Product Change Notification / NTDO-04TZHM142

CCB 4883 Initial Notice: Qualification of CEL-8240 as a new mold compound for 2N700x, DNx5xxN3, LP0701N3, TxxxxxN3, VNxxxxxx and VPxxxxxx device families available in 3L TO-92 package assembled at CRTK assembly site.

Pre and Post Change Summary

PCN #: NTDO-04TZHM142

Lead Frame Comparison

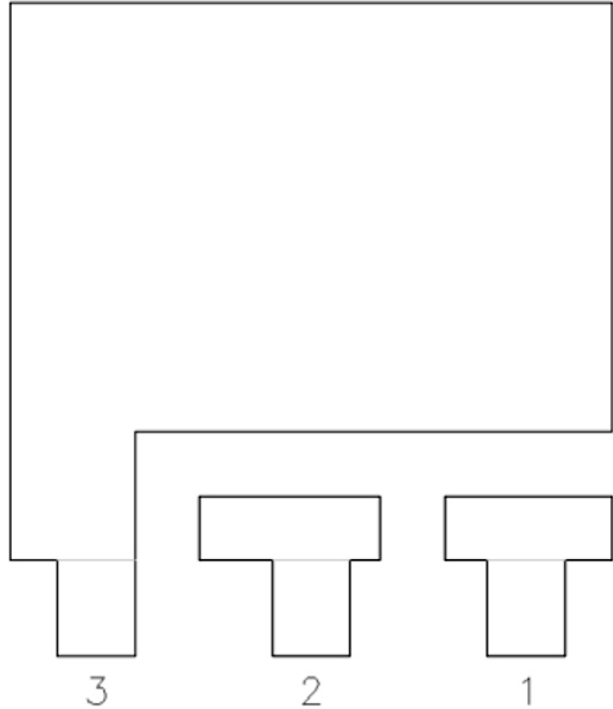
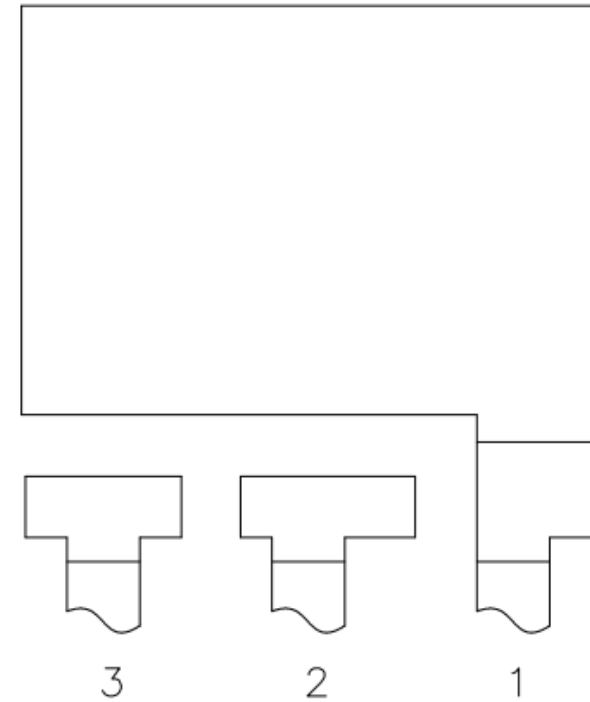
Lead Frame Material	CDA194 / A194
Lead-lock (Locking Holes)	No

Lead Frame Material*	A194
Lead-lock (Locking Holes)	No

Note:*C194, A194 or CDA194 Lead frame material are the same, it is just a MCHP internal labelling difference.

Package Layout

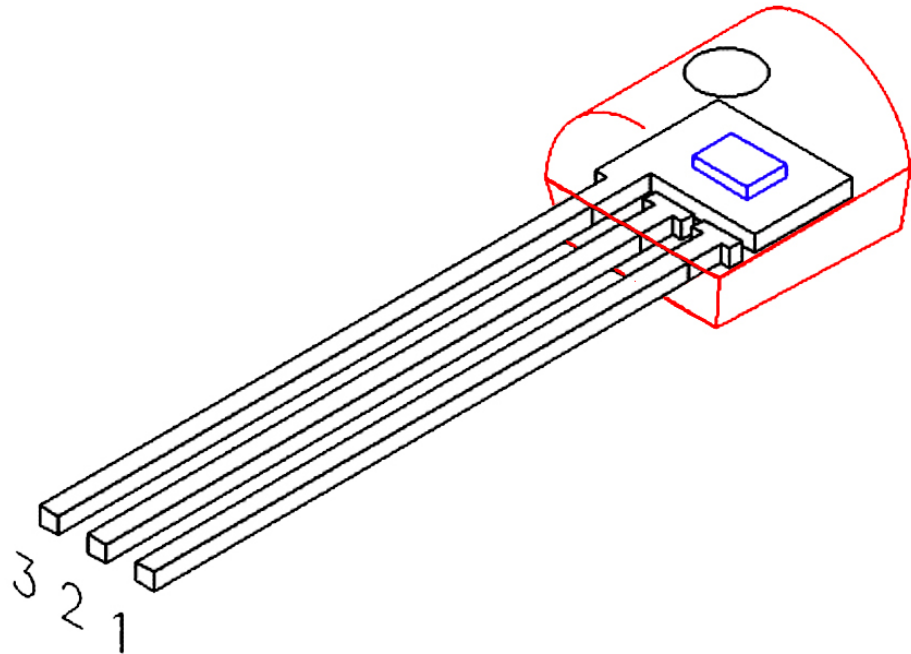
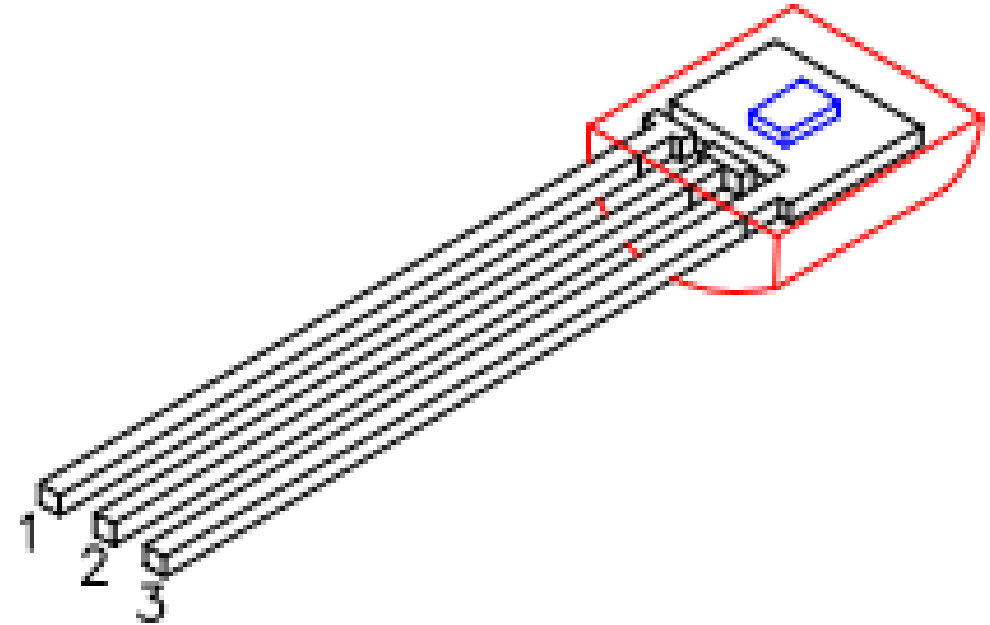
Die sit on flat side
